ADDENDUM #4

PROJECT: Bridge Classroom Portable at Woodbridge ES
Lodi Unified School District

DATE : October 23, 2025

M1.0

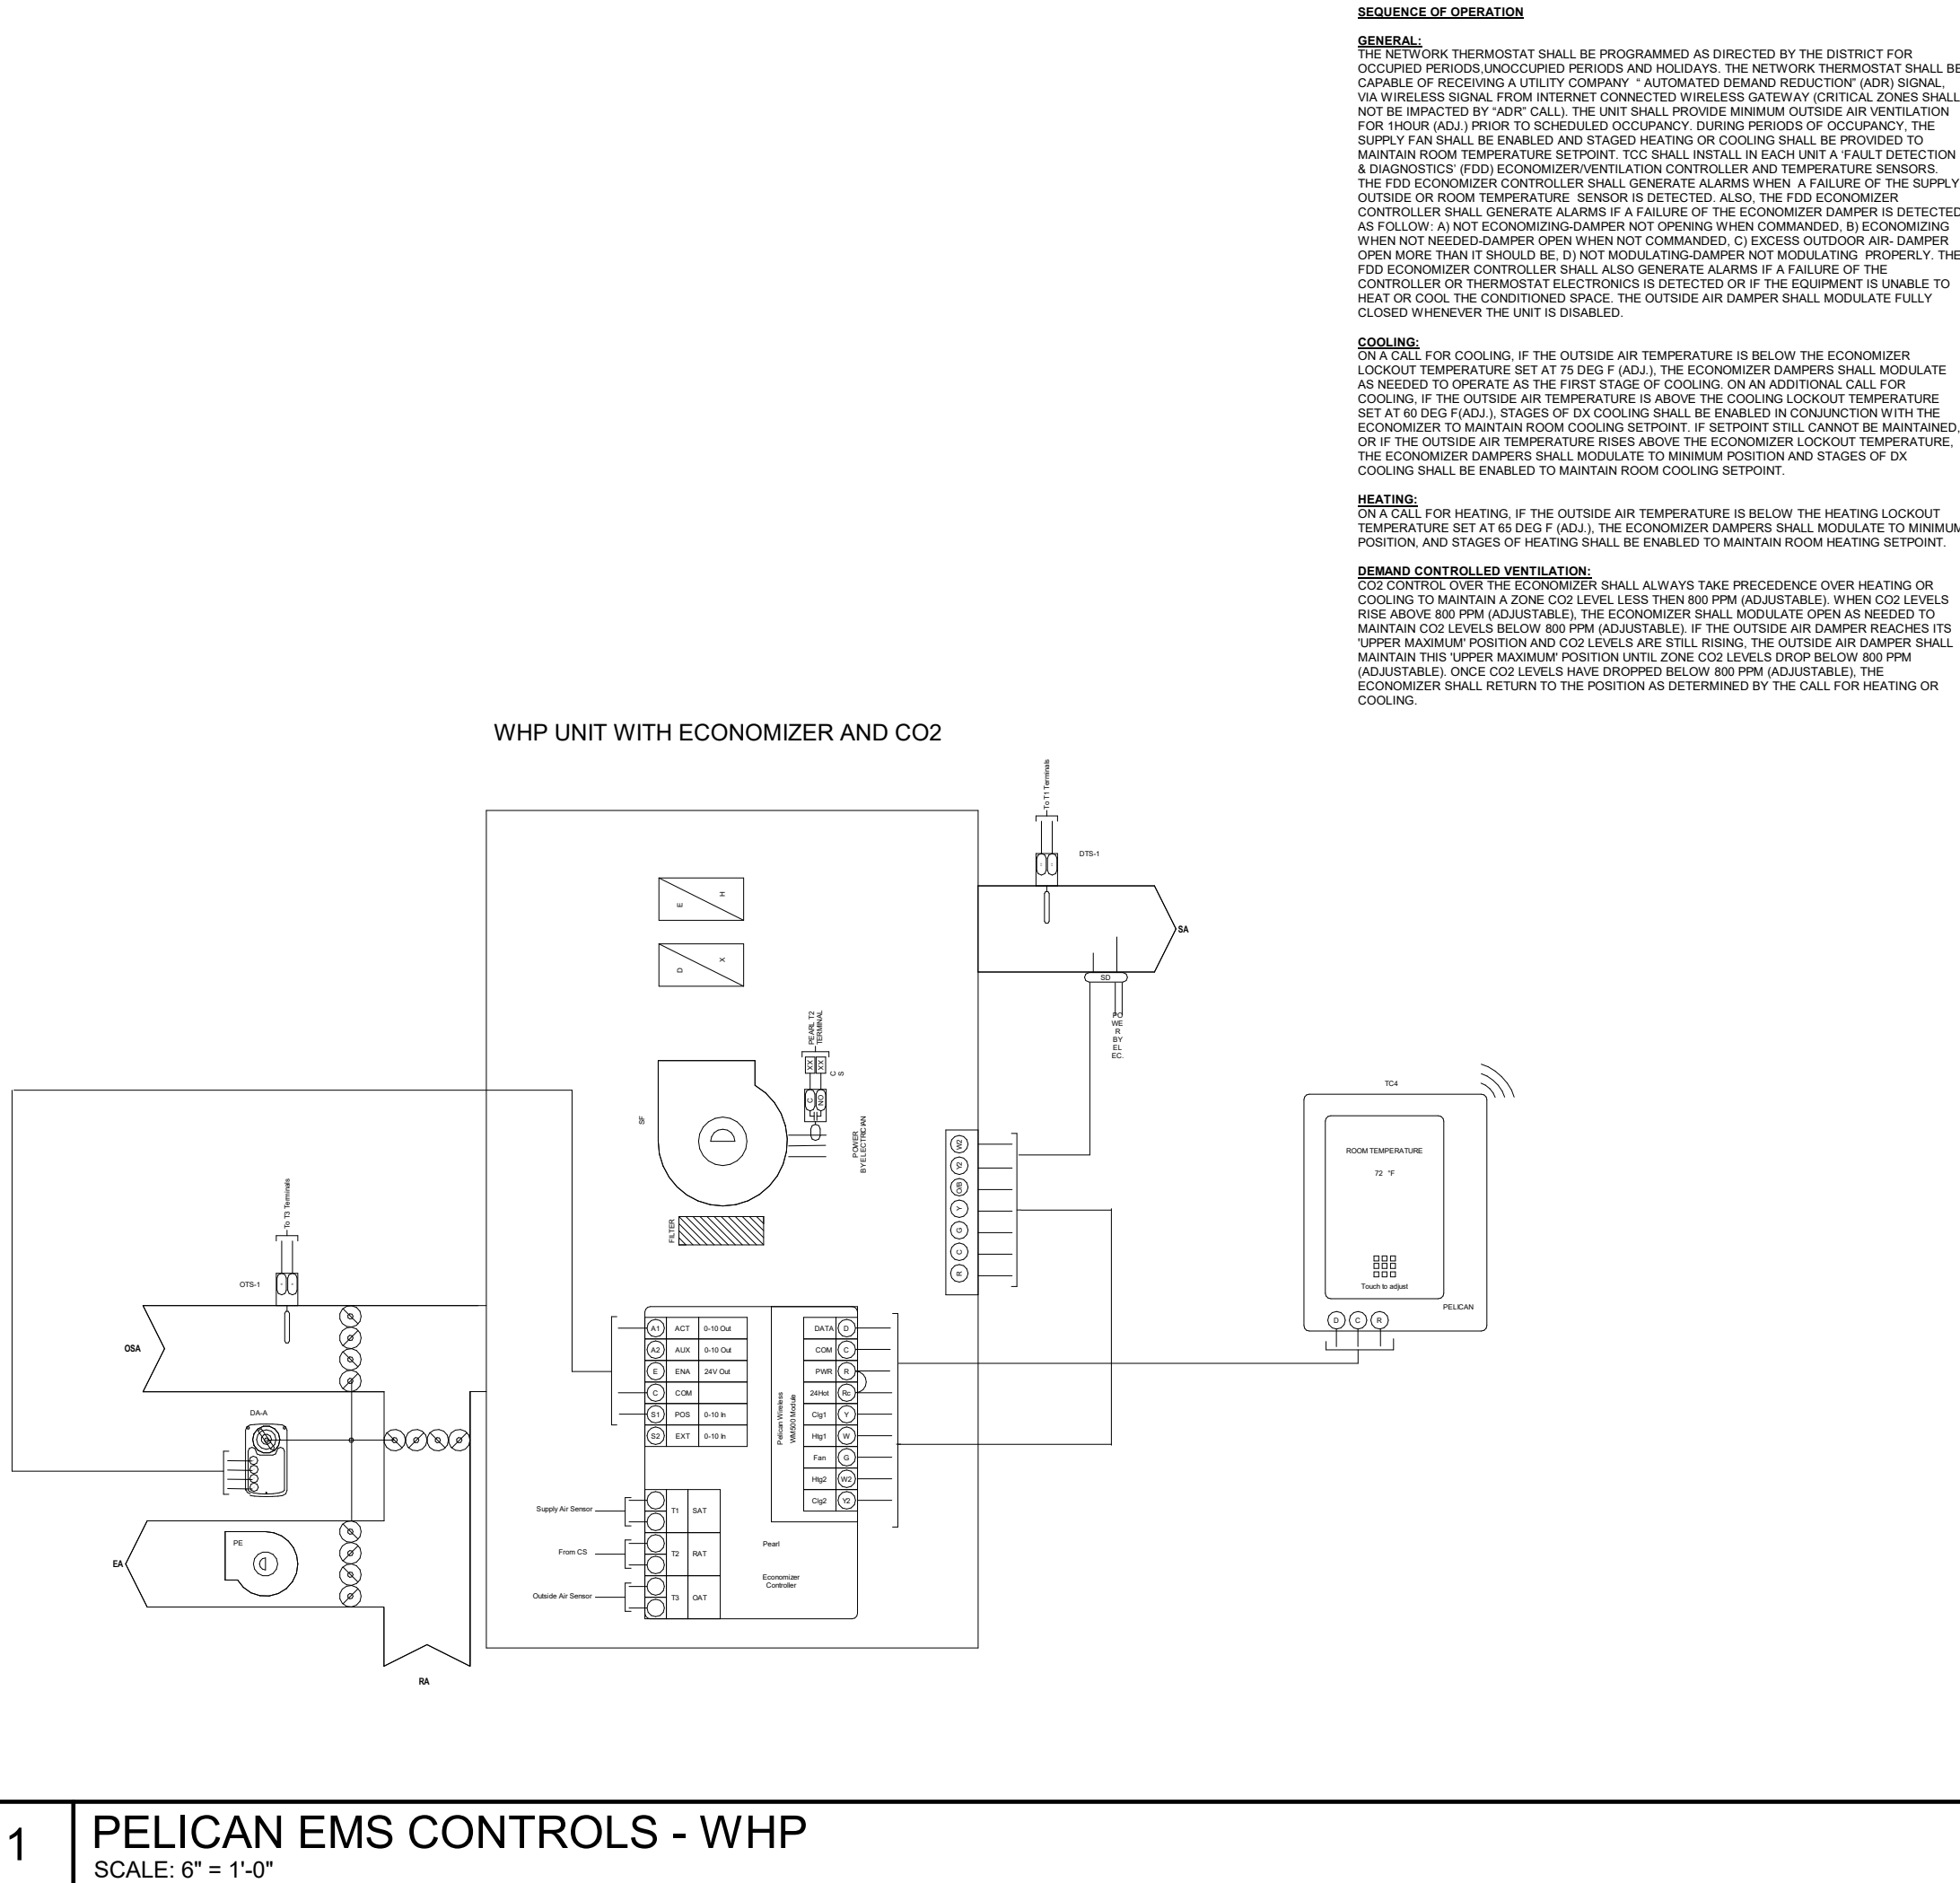
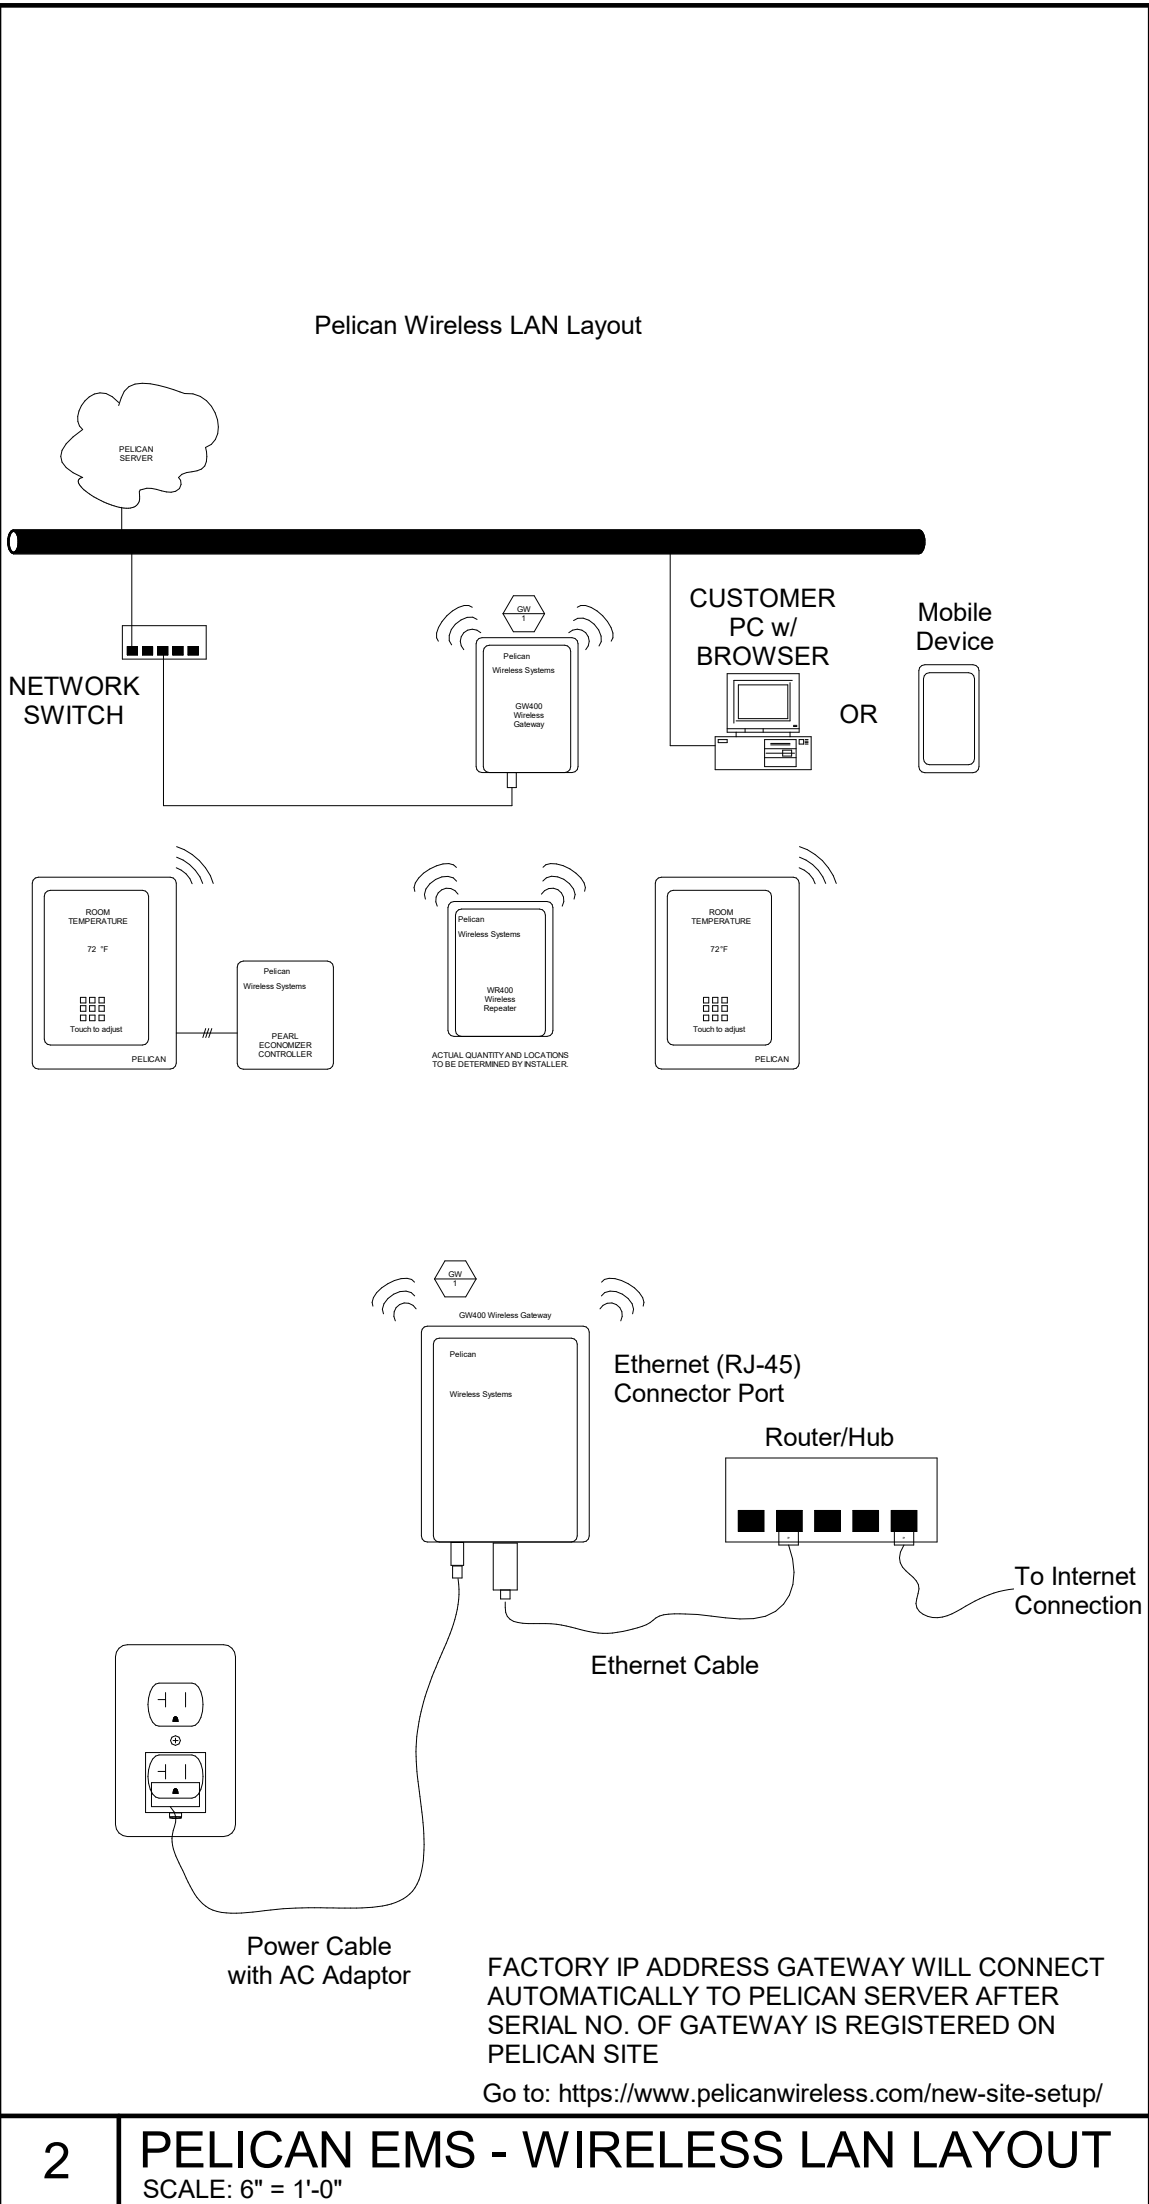
Connect the new HVAC unit on the building to the existing site Pelican EMS System per the attached Pelican controls details on attached sheet M1.0. Provide the necessary data drop with POE iP cabling as called for in the details. Confirm proper operation and connectivity prior to turning building over to the school district for their use.
